Safety Evaluation Report Related to the Renewal of
the Facility Operating License for the TRIGA Nuclear Reactor at the
University of Utah

October 2011
Office of Nuclear Reactor Regulation
U.S. Nuclear Regulatory Commission

Figure 2-3 UTR control rod worths, shutdown reactivity, and excess reactivity

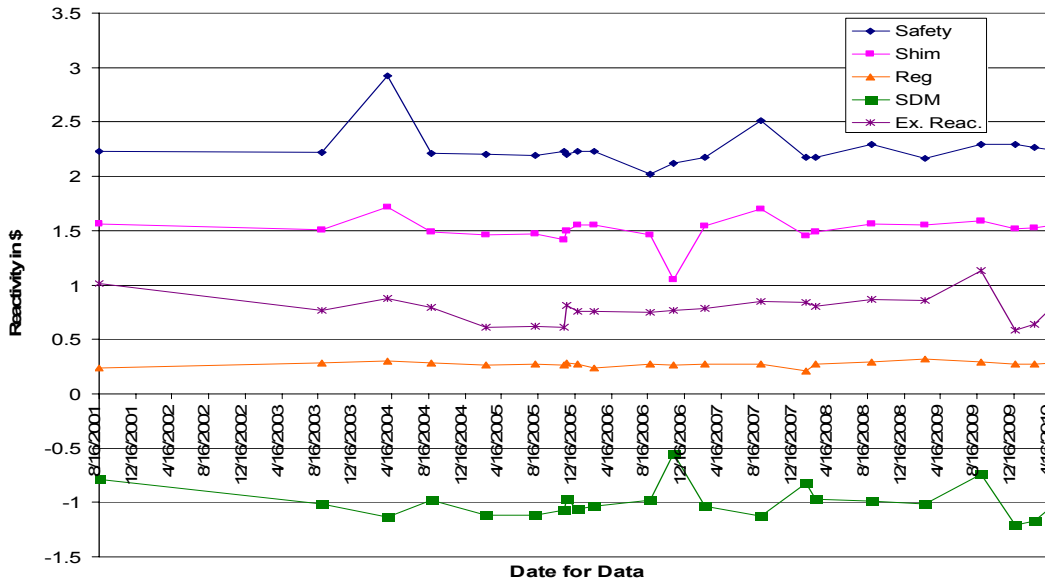
Figure 2-3 is provided below using information obtained from SAR Table 4.2-5. The rod worths for the safety, shim, and regulating control rods are based on the measured values performed every 6 months, and demonstrate consistent data.

The NRC staff concludes that the control rod worths, both calculated and measured, are acceptable.

Figure 2-5 GA-7882, confirmatory, and UUTR fuel temperature coefficients

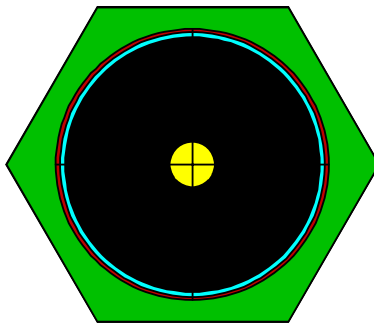
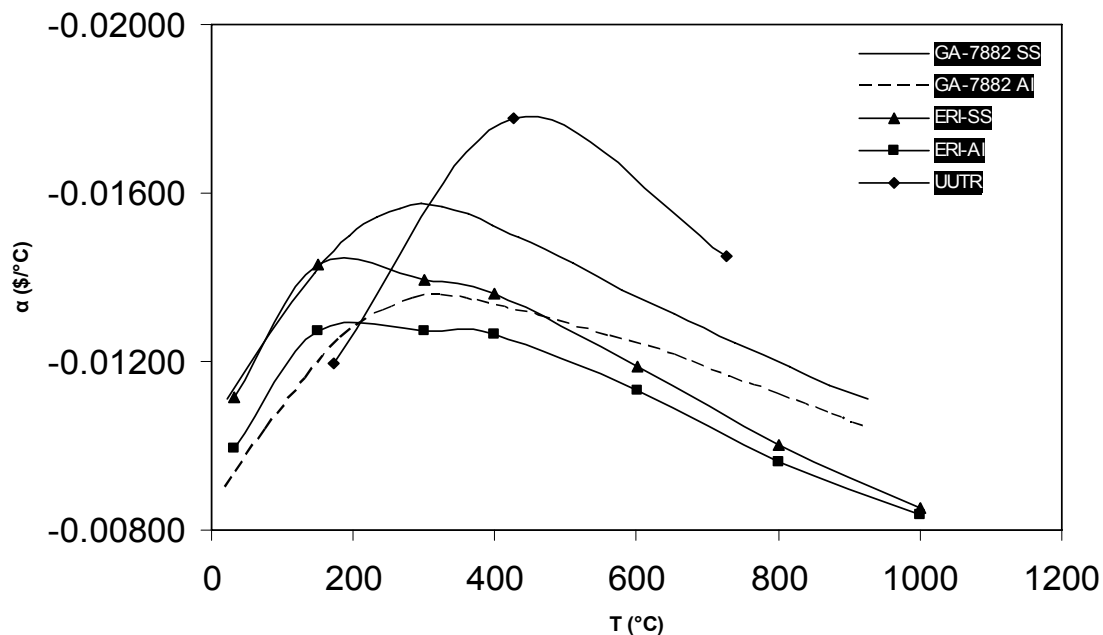
The NRC staff performed a series of calculations of the UUTR FTC using a unit cell in an infinite lattice. The general model in Figure 2-4 below contains a central rod region for stainless-steel-clad fuel elements. This region contains only fuel in aluminum-clad fuel elements. The physical dimensions of the model were taken from the UUTR SAR.

The NRC staff used the program WIMS-ANL (see “ANL/TD/TM99-07, “WIMS-ANL User Manual,” Revision 6, issued February 2004 (Ref. 18)), to perform the confirmatory analysis. This program uses a 69-group library that was specifically developed for RTR confirmatory analysis. This library has nuclear cross-section data covering a wide range of temperatures (300–1,600 kelvin (K)) and used representative spectra for TRIGA fuel. The confirmatory calculations were performed at seven temperatures of interest (31, 150, 300, 400, 600, 800, and 1,000 degrees C). At each temperature, a pair of eigenvalue calculations was performed (e.g., for 150 degrees C, confirmatory calculations were performed at 145 and 155 degrees C). Coefficients were calculated at each temperature of interest. Representative buckling values were used to model core average leakage.

The GA results (Ref. 14), the confirmatory results, and the UUTR results are displayed in Figure 2-5 below. The confirmatory results are consistent with the values and the trend of the GA results as shown in Figure 2-5 below. The UUTR results are core averaged with both stainless-steel and aluminum-clad fuel elements.

The NRC staff concludes that the calculation of the FTC by the licensee was acceptable.

Figure 2-6 Uncontrolled rod withdrawal—77 seconds

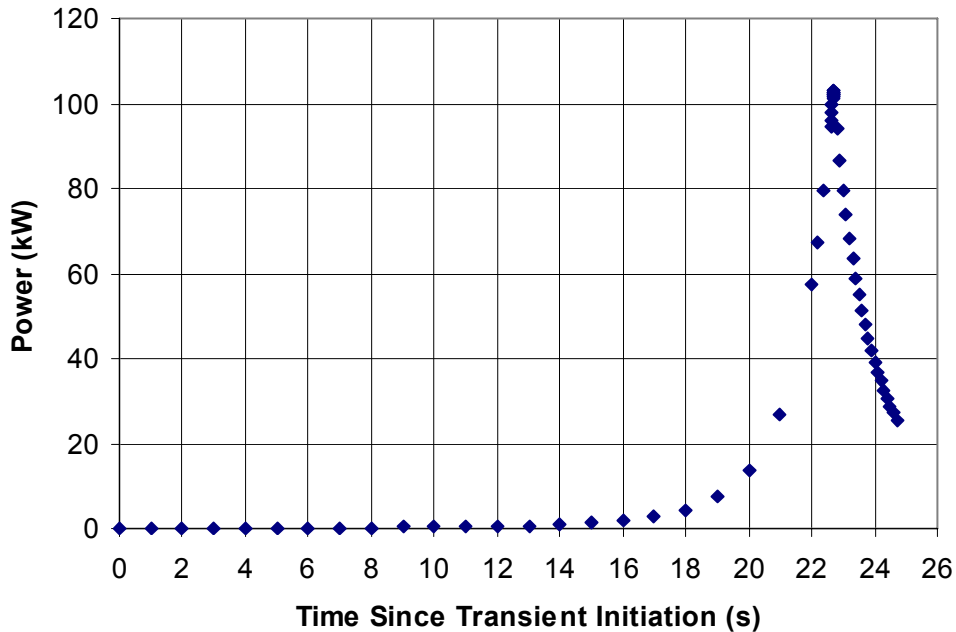
The NRC staff performed a confirmatory analysis on the uncontrolled rod withdrawal scenario. The ramp insertion model is based on the hyper-geometric function technique presented in the UUTR SAR Section 4.5.3.10. This technique was outlined in Hetrick (Ref. 19), and the results are provided in Figure 2-6 below. In this transient, the highest worth control rod was withdrawn at the maximum withdrawal rate allowed by the UUTR TS until a reactor scram occurs at 100 kW.

In this confirmatory analysis, the trip signal is generated at 100.39 kW and occurs 22.68 seconds after initiation of the transient. Power increases to 103.18 kW because of the 0.02-second delay time before the control rod insertion. The control rods insert at the rate provided by TS 3.2.1, which is 2.0 seconds. A total reactivity of \$0.66 was inserted by the uncontrolled withdrawal of the control rod. The results are acceptable for two reasons: (1) the reactivity insertion limit is not reached (+\$1.20), and (2) the resulting power of 103 kW does not pose a DNBR or fuel temperature problem. Section 2.6 contains the DNBR analysis. This confirmatory analysis replicates the results provided in UUTR SAR Section 4.5.3.10.

Figure 2-7 Uncontrolled rod withdrawal—7.5 seconds

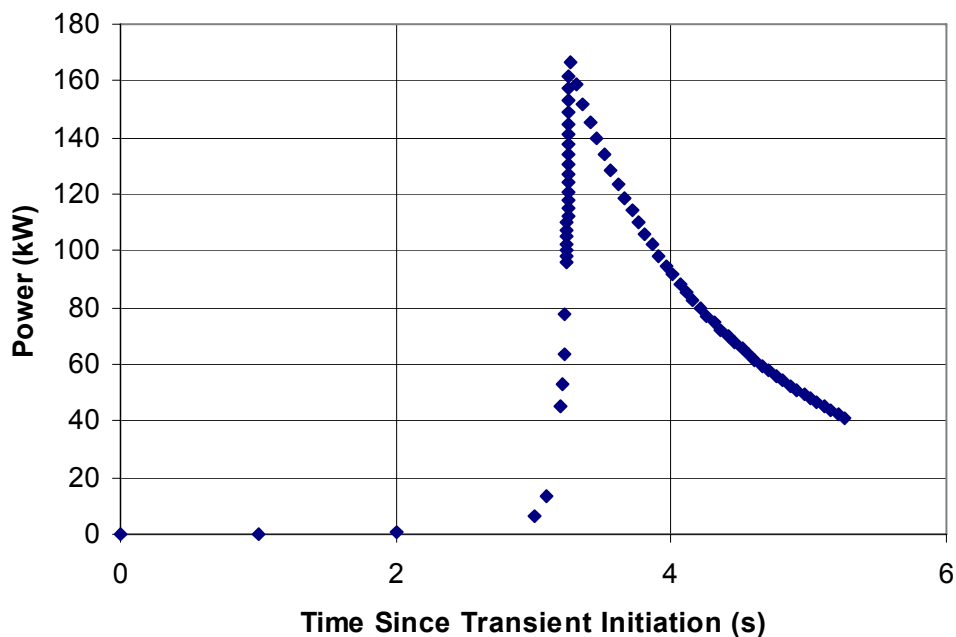
The NRC staff performed a confirmatory calculation using the maximum reactivity insertion rate of $\$0.30/s$, as specified in TS 3.2.1, Specification 3. This reactivity insertion rate ($\$0.30/s$) corresponds to a control rod withdraw from fully inserted to fully withdrawn in 7.5 seconds. The results of the 7.5s control rod withdrawal time are provided in Figure 2-7 below.

In this confirmatory analysis, the trip signal is generated at 100.12 kW and occurs 3.242 seconds after initiation of the transient. Reactor power increases to 166.27 kW as a result of the 0.02-second control rod insertion delay. The control rods insert within the TS 3.2.1 time of 2.0 seconds. A total of $\$0.98$ of reactivity was inserted by the uncontrolled withdrawal of the control rod. The results are acceptable because the reactivity insertion limit is not reached ($+\$1.20$), and the resulting reactor power of 166 kW does not pose a DNBR or a fuel temperature challenge.

Figure 2-8 DNBR and CHF for UUTR

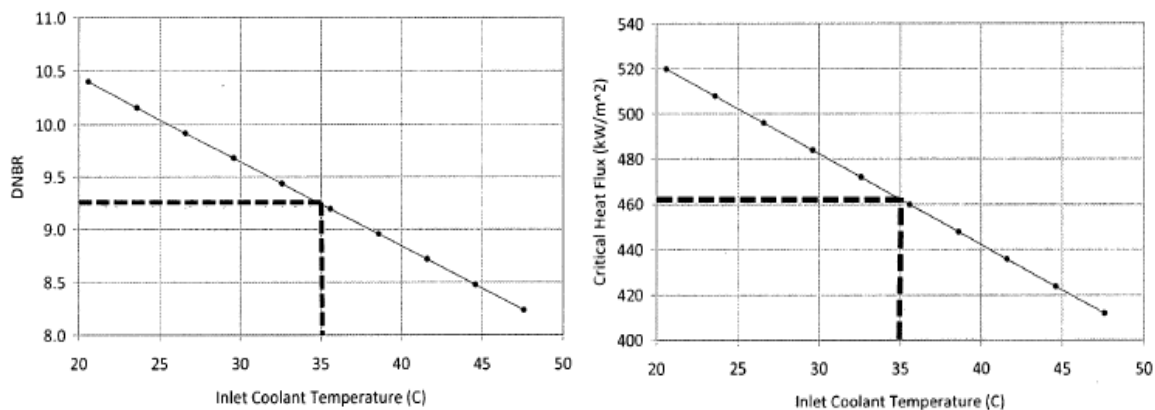
Using PARET-ANL and the Bernath correlation, the licensee has evaluated the UUTR DNBR. The results for DNBR and CHF are given in UUTR SAR Figures 4.6-9 and 4.6-10, respectively, and are reproduced below in Figure 2-8. It is clear from this evaluation that the DNBR stays above 8.0 for various coolant inlet temperatures in the hottest channel. This DNBR value represents a safe region for the reactor operation in terms of fuel and clad integrity.

The licensee also provided calculations for a pool temperature up to 90 degrees C, even though the UUTR TS limit the pool temperature to 35 degrees C. The calculations for a pool temperature of 90 degrees C results in a DNBR of 5.11, and is still acceptable for the safe operation of UUTR. The NRC staff finds that, within the valid pool water temperatures at atmospheric pressure, the DNBR will always stay in an acceptable range at the licensed power level. The NRC staff concludes that the calculated minimum DNBR of 8.0 was expected and is consistent with the DNBR results provided by other TRIGA reactors. The NRC staff concludes that the DNBR evaluation for UUTR is acceptable.

Figure 4-1 Comparison of TEDE calculations for individuals in the MEHL

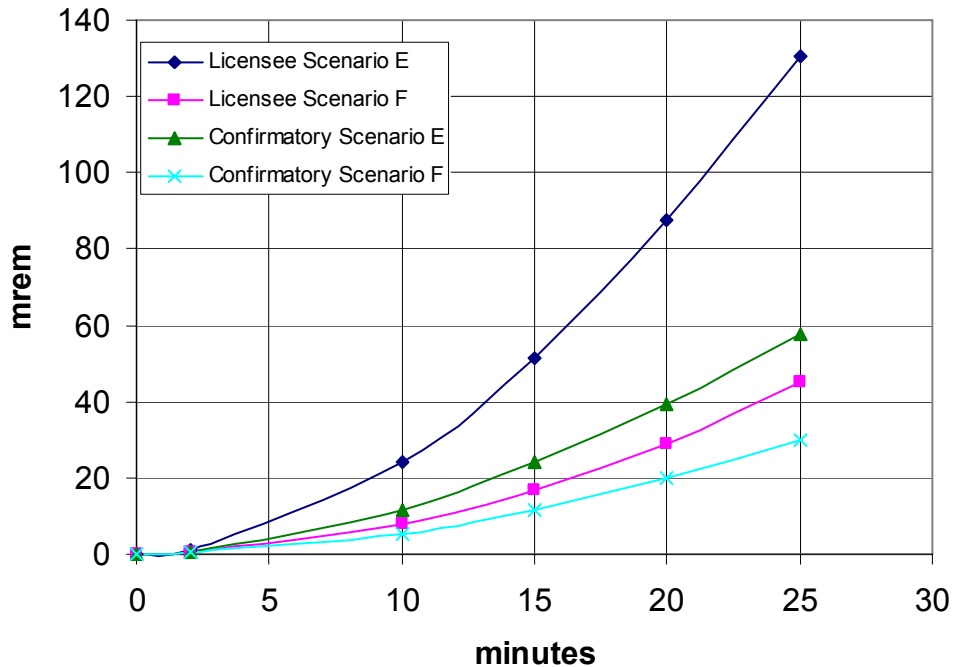
Table 4-5 and Figure 4-1 below present the calculations for the UUTR SAR MEB and MEHL and the confirmatory dose calculations.
